CITY OF ALBUQUERQUE

**Re: McDonalds - 8315 Montgomery Blvd NE
Tract A-1-F of the Los Pastores Shopping Center
Grading and Drainage Plan - Engineer's Stamp date 4/4/2019 (F19D013A)**

RE: 8315 Montgomery Blvd. NE (F19D013A)— HYDROLOGY COMMENTS

DRAINAGE AND TRANSPORTATION INFORMATION SHEET (REV 11/2018)

POND 4: 0.25-FT DEEP SPILLWAY

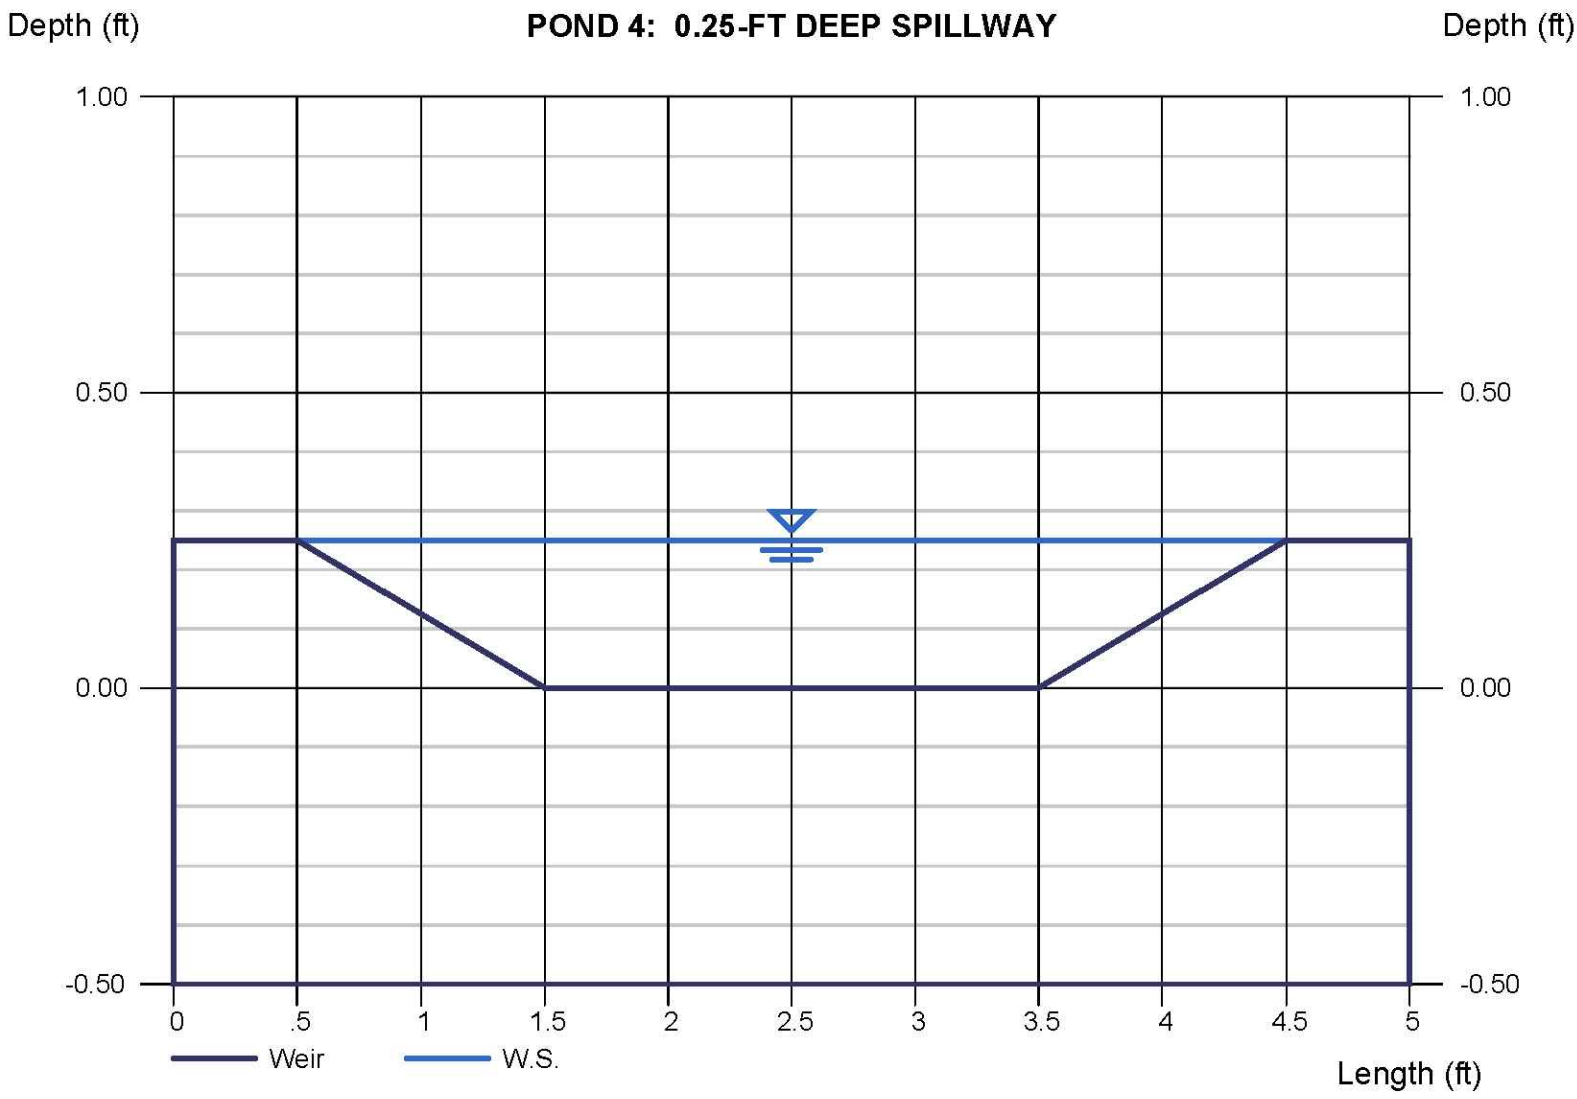
5. Ponds #1 and #4 appear to have been deleted from the plan, Sheet C8.1 or are not labeled. If so, please delete the Stage Storage Volume table from sheet C8.2 for those two ponds. Also delete them from the "Pond FF Elevation Table" on that sheet. The second table titled "First Flush Volume Calculations" should look more like the one below using the volumes from the "Stage Storage Volume" tables.

C8.3

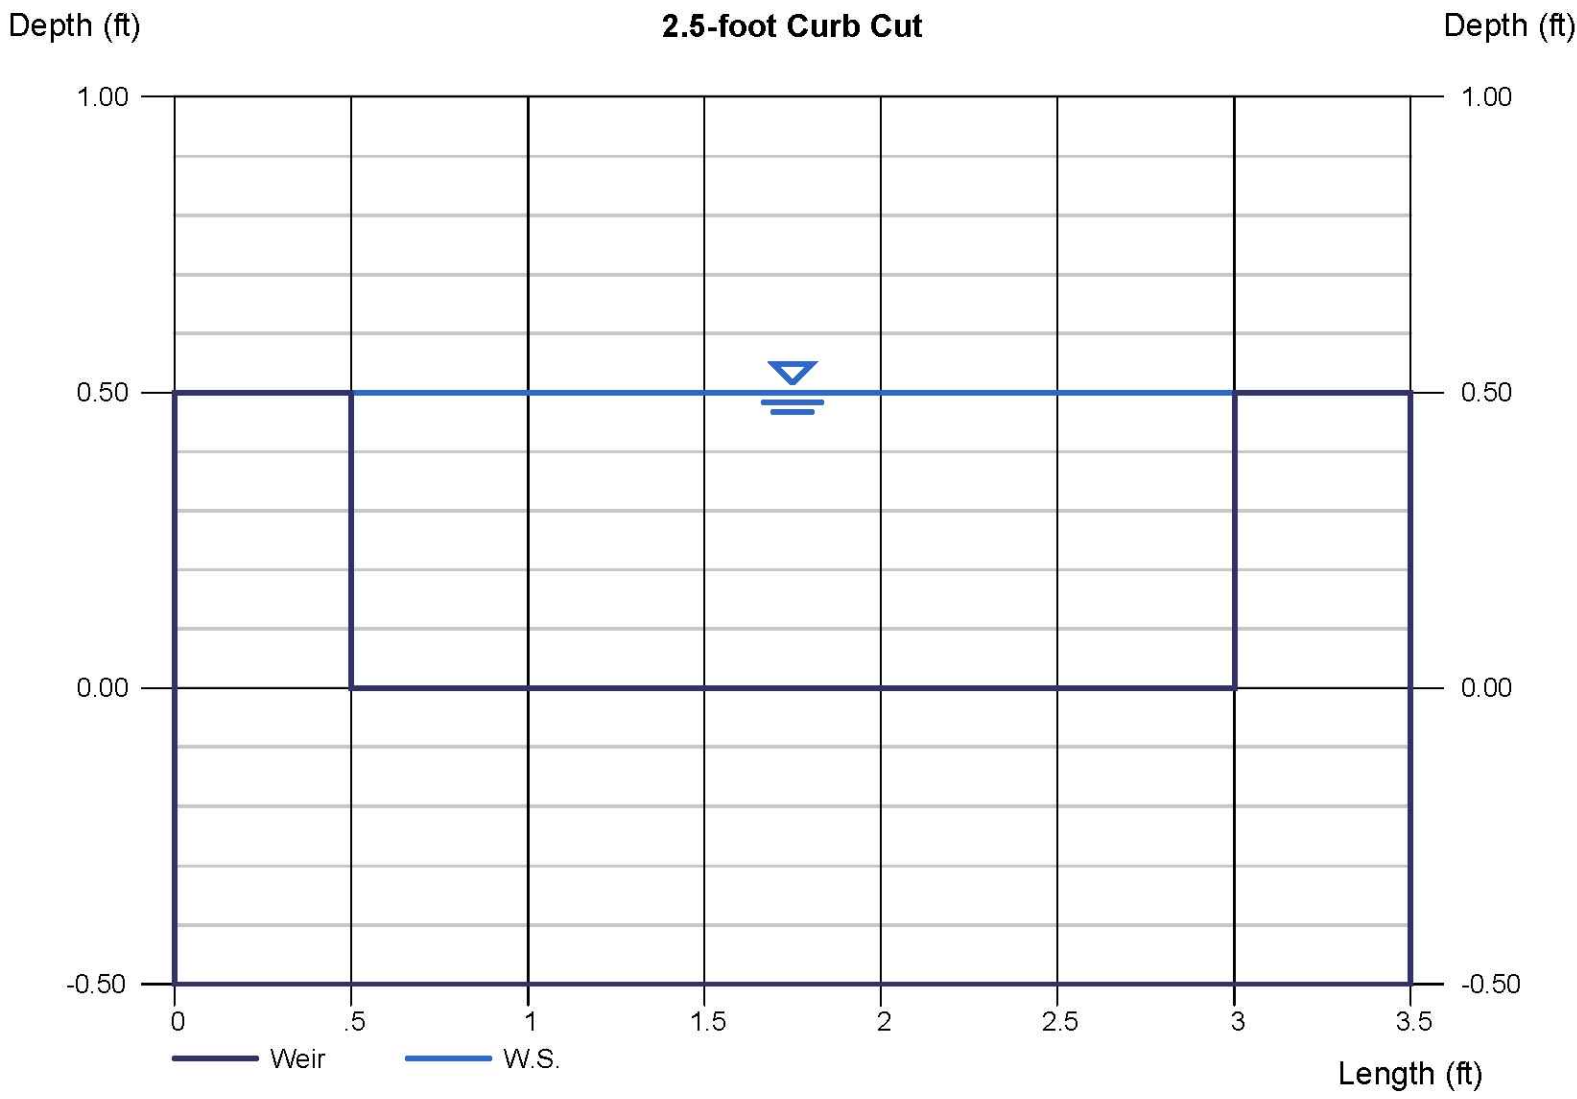
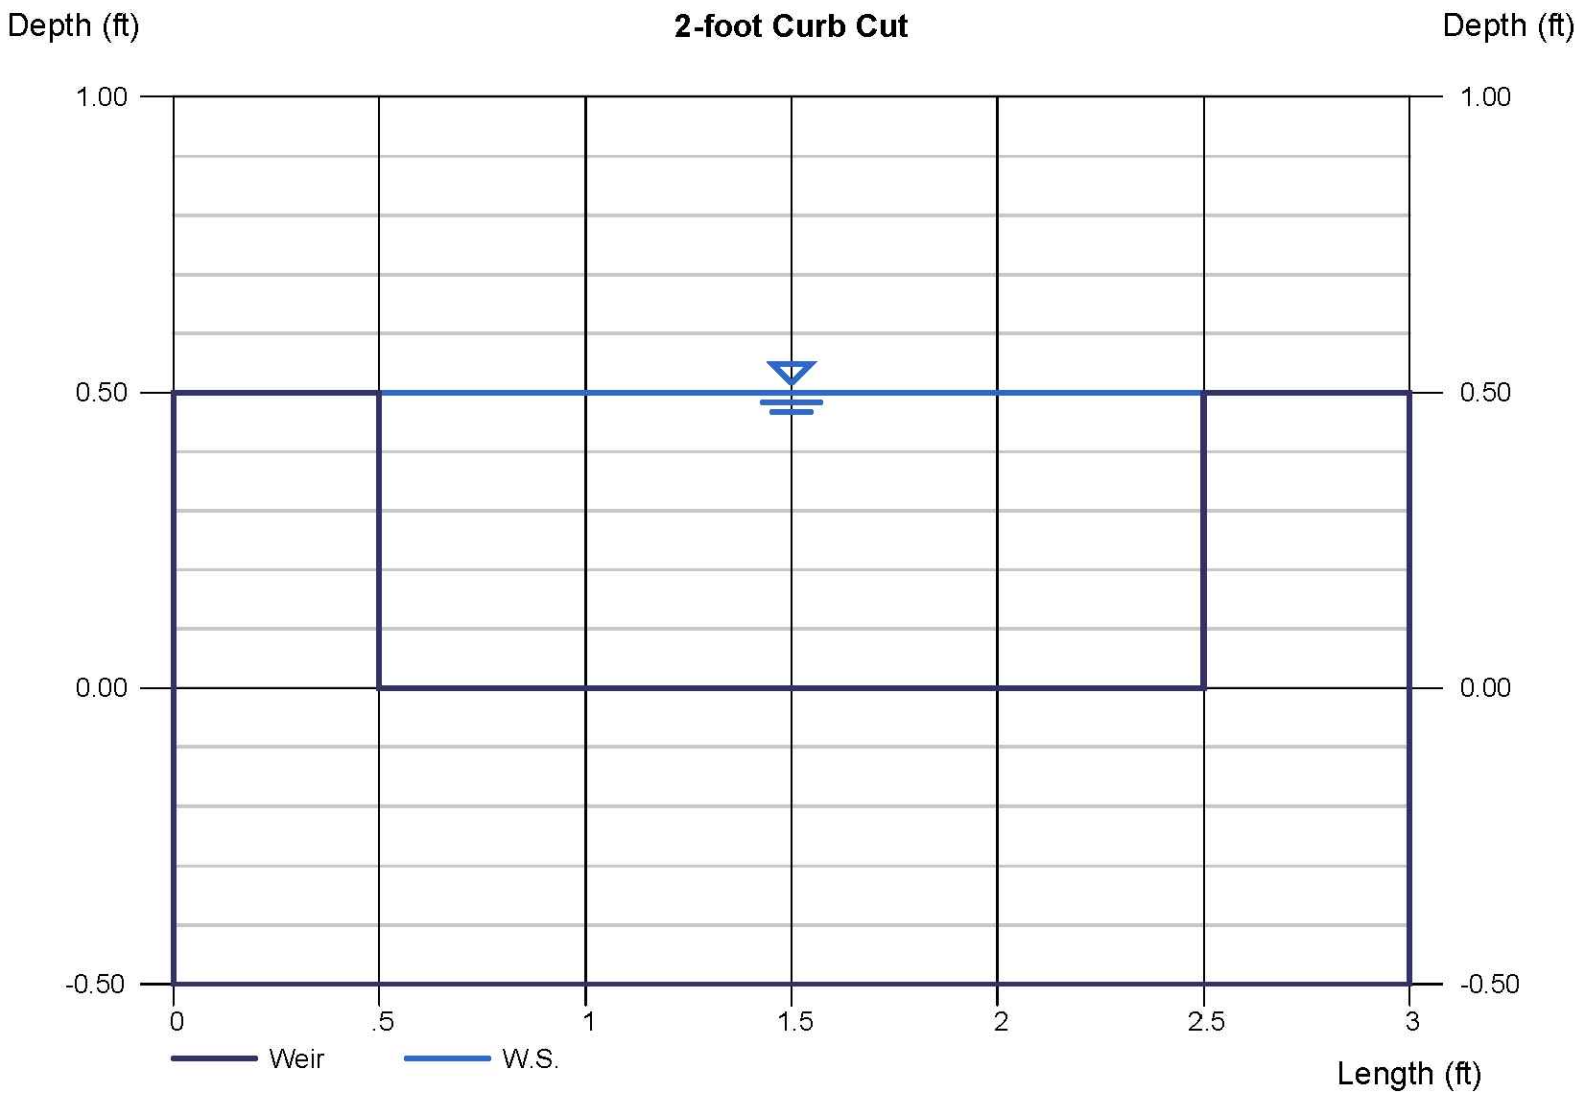
- 7) 7. Any portion of the peak 100 year flow rate that drains into Montgomery Blvd. will have to do so through appropriately sized sidewalk culverts. Use the weir equation to size the culvert not Manning's normal depth. The typical capacity is about 1.25 cfs per foot of opening, so two 2' wide culverts should be used. The sidewalk culvert must also extend all of the way from the curb to the right of way, and the invert should be specified at that location instead of the back of sidewalk. The culverts should be moved as far west as possible to the low corner of the pond. **Culverts have been removed and flow over a lowered-curb weir into the alleyway has been added. Los Pastores DMP and McDonald's plans reflect this modification.**
